# ZONING COMMITTEE STAFF REPORT

**FILE NAME:** 1179 E 7th St. CUP **FILE #** 21-302-448

**TYPE OF APPLICATION:** Conditional Use Permit

A. **PURPOSE:** Conditional use permit (CUP) to convert the entire first floor of a commercial building to residential use.

2 A3.1 SOUTH (FRONT) ELEVATION
SCALE 1/8" = 1'-0"
0 1 2 3 4 6 8 10 14 18 26

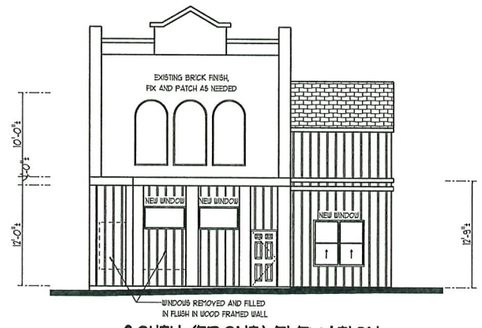
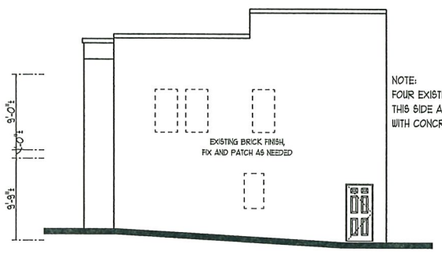
2. § 66.341(d) requires that *"in conversion from commercial to residential use, the elements of traditional storefront design, where present, shall be retained. These include door and window openings, display windows, intermediate cornice lines, sign bands, awnings, arcades, and primary entrances facing the public street."* The building at 1179 E 7th Street was constructed in 1890, designed for commercial use on the first floor and apartments on the second floor, with elements of traditional storefront design including a primary entrance at the SW corner of the building facing both E 7th Street and Duluth Street, storefront windows facing both public streets, and an intermediate cornice over the first floor storefront. A 1941 photo showing this original traditional storefront design, with window signs for wines, liquors and a café in the storefront windows, is attached.

Attached photos from 2019 and an August 2021 Google street view show elements of the traditional storefront still intact, including the storefront window facing Duluth Street, the westernmost of the two storefront windows facing E 7th Street, vertical brick storefront piers, and

the intermediate cornice over the storefront. The photos show that the original corner column outside the corner entrance has been removed. While the photos show that the door opening at the SW corner of the building has been become a storefront window and partially covered with wood, the upper part of easternmost of the two storefront windows facing 7th Street was used for a vent and the lower part covered with wood, a narrow column separating the two storefront windows facing 7th Street was clad with bricks to resemble the historic brick piers elsewhere along the front facade, and the clerestory windows had been covered with wood, the basic structure of the traditional storefront facade door and window openings still exists. Plans submitted with the application showing the original angled primary entrance area at the SW corner of the building boxed in and covered over with vertical siding, and showing large portions of the original storefront window openings covered over with vertical siding, are inconsistent with and do not meet the requirement in § 66.341(d) to retain these elements of the traditional storefront design of the building.

Modification of the special conditions in § 66.341(d) in order to allow the original angled primary entrance area at the SW corner of the building to be boxed in and covered over with vertical siding, and to allow large portions of the original storefront window openings to be covered over with vertical siding, would impair the intent and purpose of the requirement in to retain elements of traditional storefront design in conversion of the building to residential use.

1. The elements of traditional storefront design in the building, including a primary entrance at the SW corner of the building facing both E 7th Street and Duluth Street, the historic storefront window openings facing both public streets, the historic vertical brick piers in the front facade, and the intermediate cornice over the storefront, must be retained.

2 A2.2 **PROPOSED FIRST FLOOR PLAN** ~4486 SQ.FT.
SCALE 1/8" = 1'-0"

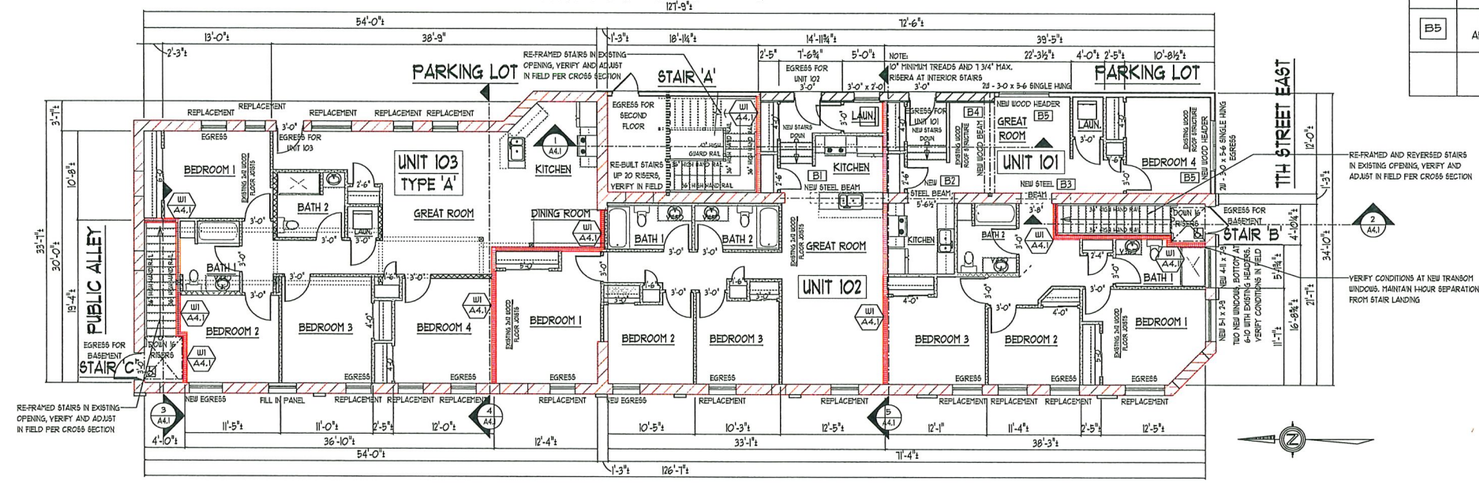
(a) Strict application of the condition in Zoning Code § 66.341(d) to retain elements of the traditional storefront design of the building would not unreasonably limit or prevent residential use of the first floor. Proposed Unit 101 for reuse of the commercial space at the south end of the building could be redesigned to take advantage of elements of the traditional storefront design as assets. For example, putting the proposed "great room" at the SW corner of the

unit could take advantage of the original storefront window openings for great light and air, and the original angled primary entrance opening at the SW corner of the building could be used as a front door.
